BURLINGTON DEVELOPMENT REVIEW BOARD

Tuesday, December 7, 2021, 5:00 PM

TO: Development Review Board
FROM: Ryan Morrison, Associate Planner
DATE: December 7, 2021
RE: ZP-21-732; 278 Main Street

TO: Development Review Board
FROM: Ryan Morrison, Associate Planner
DATE: December 7, 2021
RE: ZP-21-723; 321 Manhattan Drive

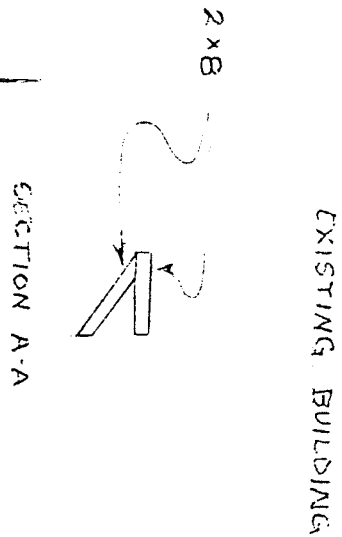
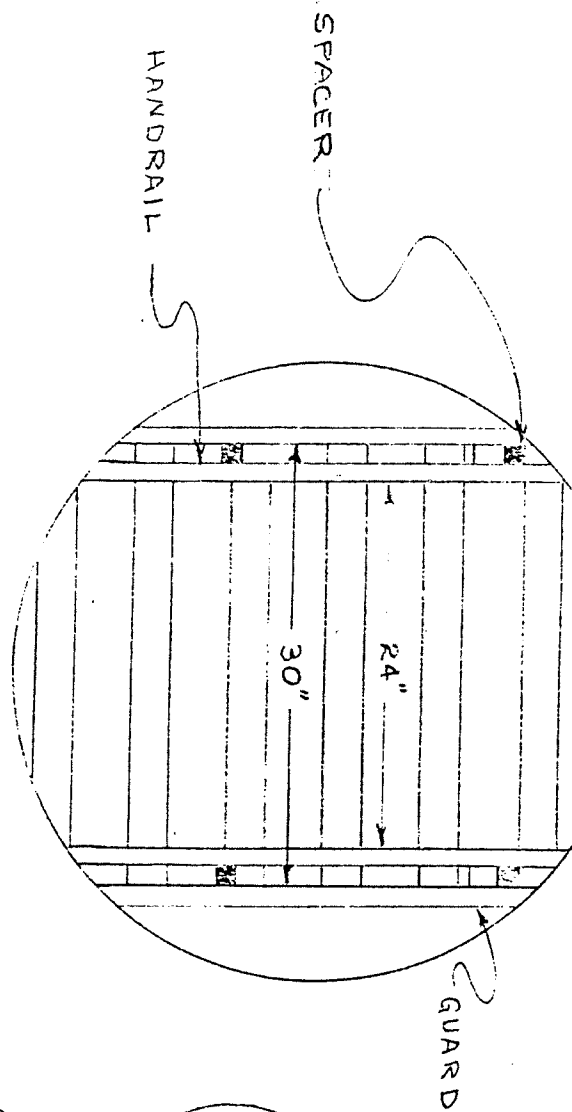
E. STAIR RISERS SHALL ^{BE NO MORE THAN 8" HIGH} ~~BE LESS THAN 8"~~
AND STAIR TREADS SHALL BE ^{LESS} ~~GREATER~~ THAN
~~8"~~ 8"

F. ALL LANDINGS AND TREADS SHALL HAVE
2X4'S PLACED ON EDGE SPACED SUFFICIENTLY
APART TO REDUCE THE ACCUMULATION OF
SNOW AND ICE. HOW?

SHALL BE CAPABLE OF MEETING
PARA 1707.4 - FIRE ESCAPES SUB-PARA G.
NAMELY THE FIRE ESCAPE SHALL BE CAPABLE
OF SUSTAINING ALL LOADS SPECIFIED
IN THAT PARAGRAPH. $\sqrt{100 \text{ LBS/SQ. FT.}}$
